TRANS/WP.29/2003/48  
11 April 2003

**PROPOSAL FOR DRAFT SUPPLEMENT 23 TO  
THE 03 SERIES OF AMENDMENTS) TO REGULATION No. 37**

(Filament lamps)

Transmitted by the Working Party on Lighting and Light-Signalling (GRE)

**Sheet R5W/1**

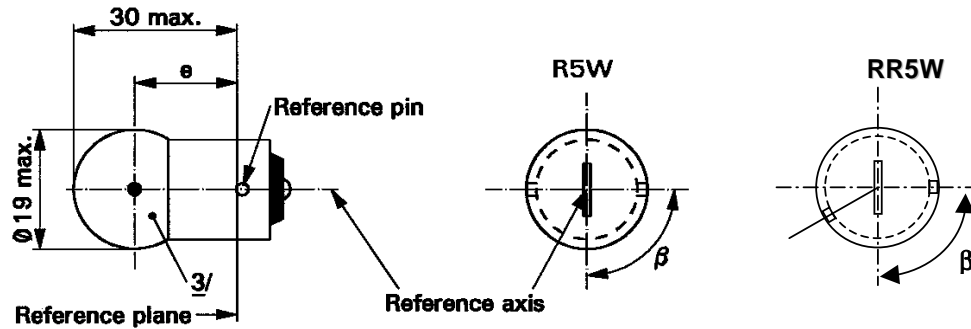
Sheet R5W/1, replace by the new sheet R5W/1 (Category R5W and RR5W).

**Sheet R10W/1**

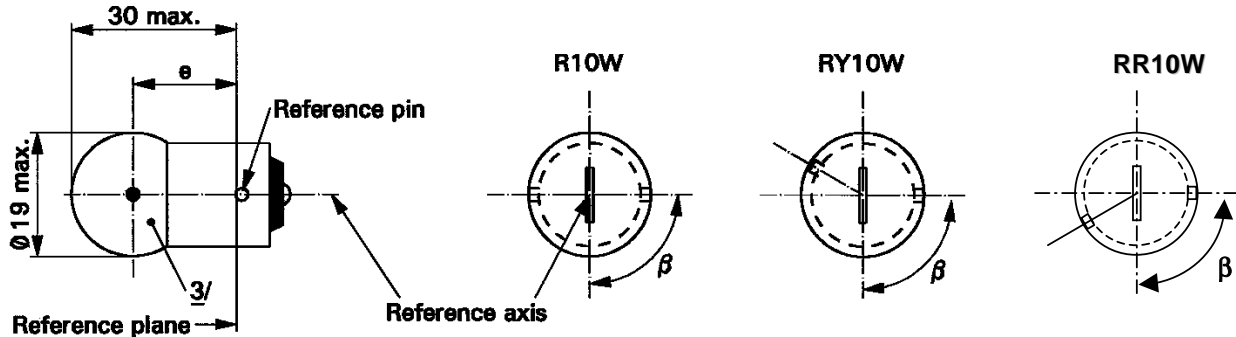
Sheet R10W/1, replace by the new sheet R10W/1 (Category R10W, RY10W and RR10W).

**Sheet W5W/1**

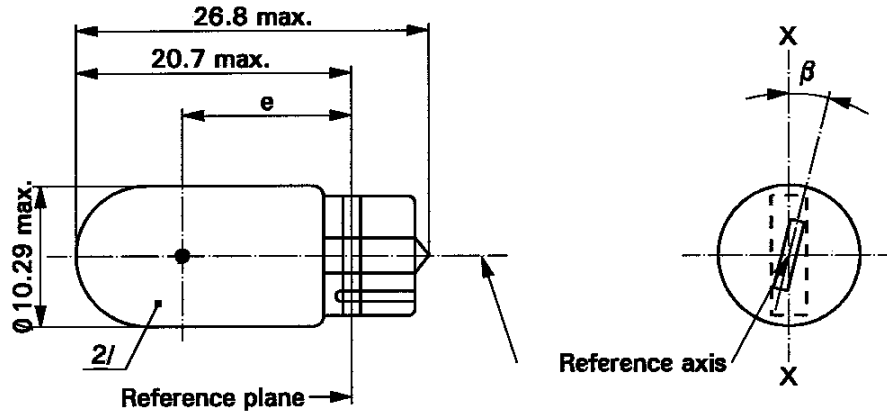
Sheet W5W/1, replace by the new sheet W5W/1 (Category W5W, WY5W and WR5W).

Sheet PY27/7W/1

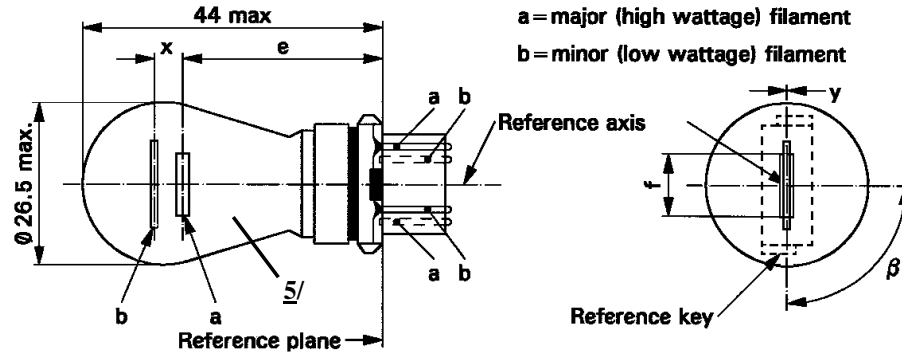
Sheet PY27/7W/1, replace by the new sheet PY27/7W/1.

**Sheet P19W/1**

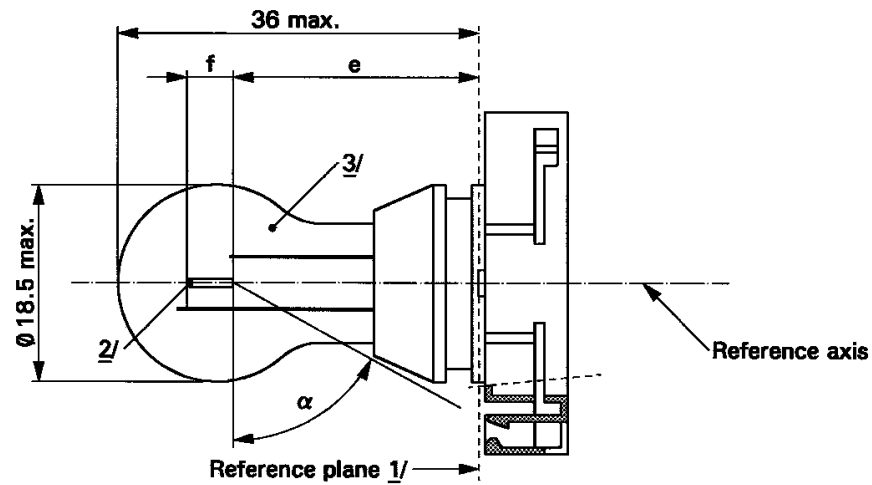
Sheets P19W/1 to P19W/3, replace by the new sheets P19W/1 to P19W/3 (Category P19W, PY19W, PR19W, PS19W, PSY19W, PSR19W).

Sheet PR21W/1

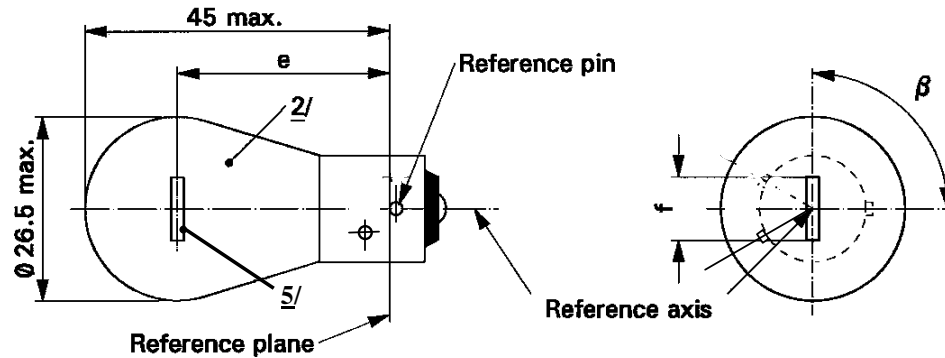
Add at the end new sheets PR21W/1, PR21/4W/1, PR21/5W/1 and PR27/7W/1.

Sheet HS5/3

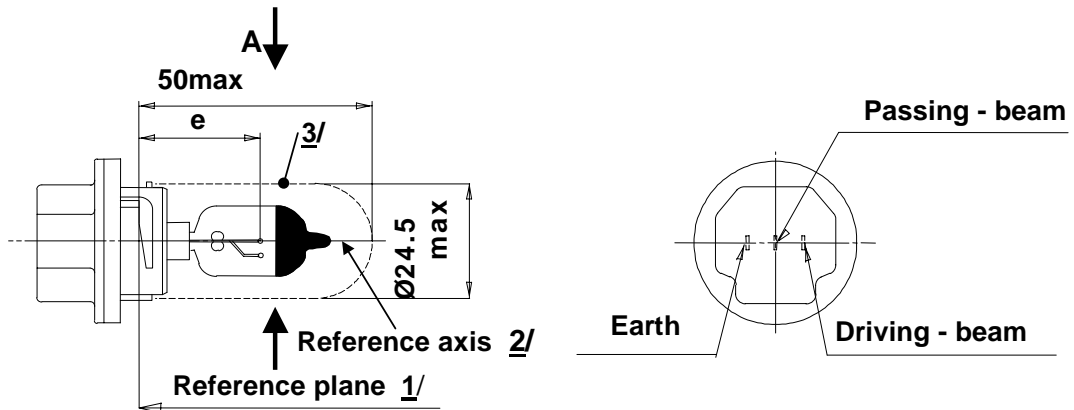
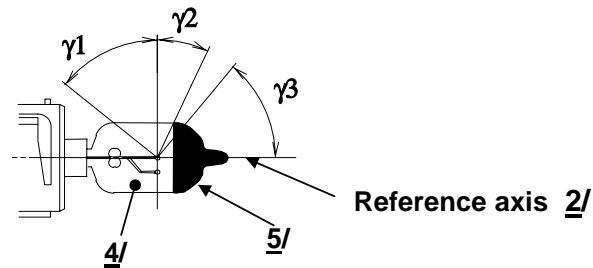
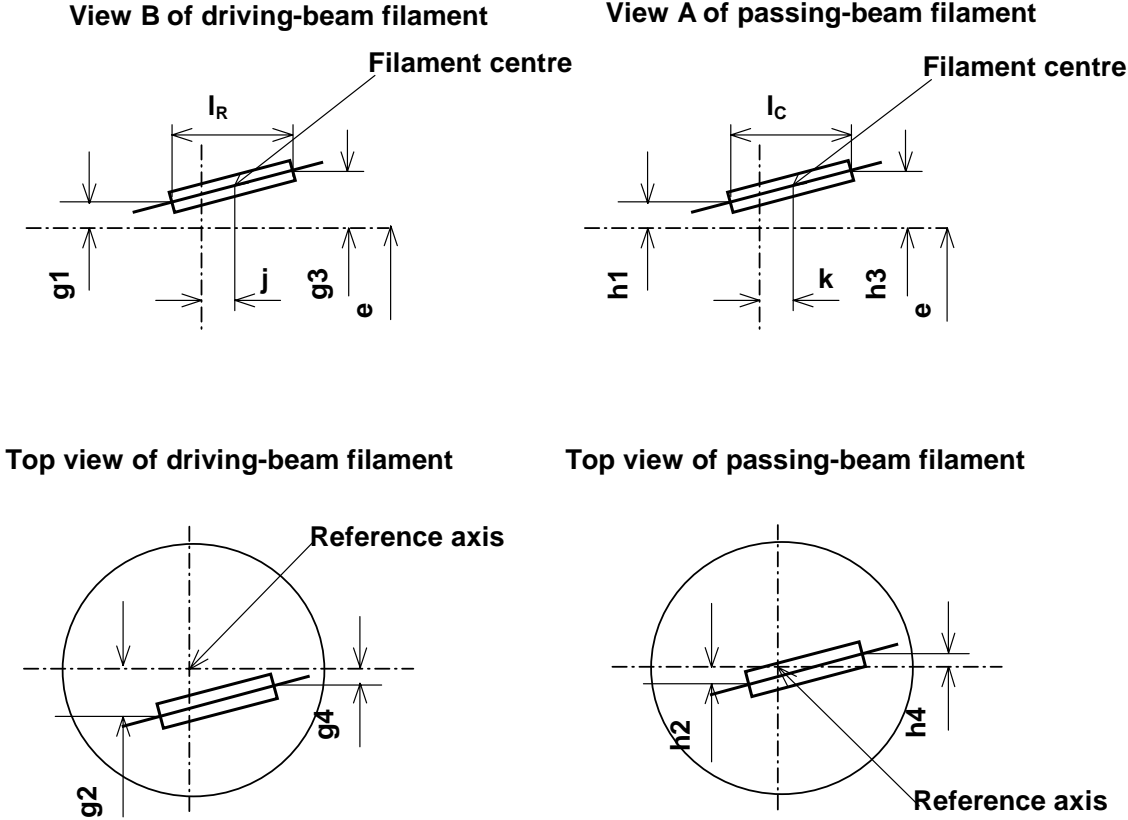
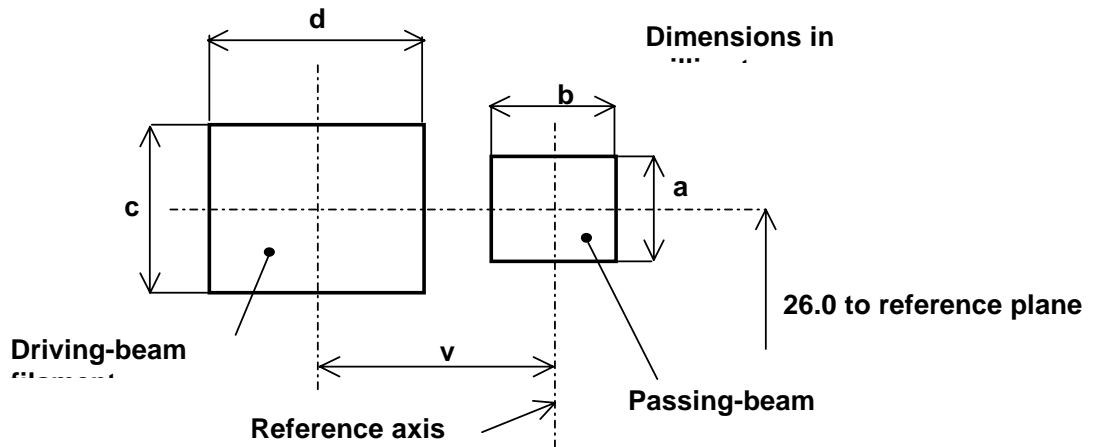
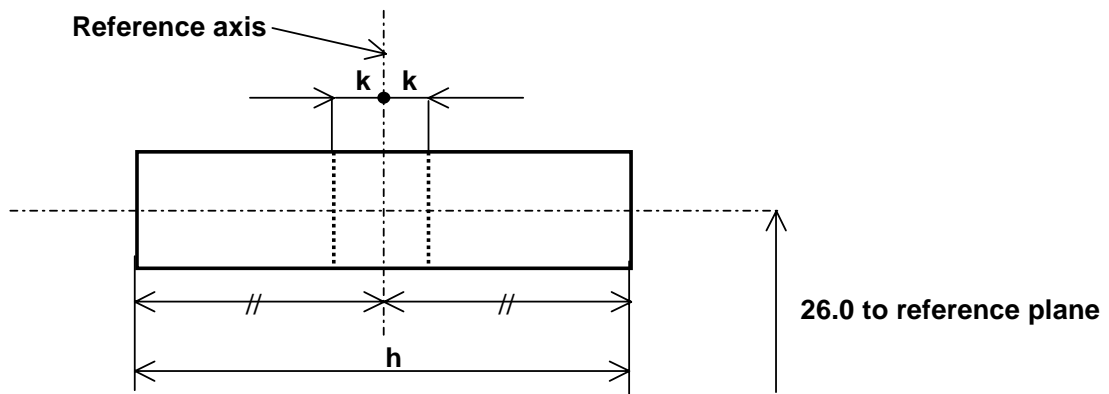
Add at the end new sheets HS5/1 to HS5/4.
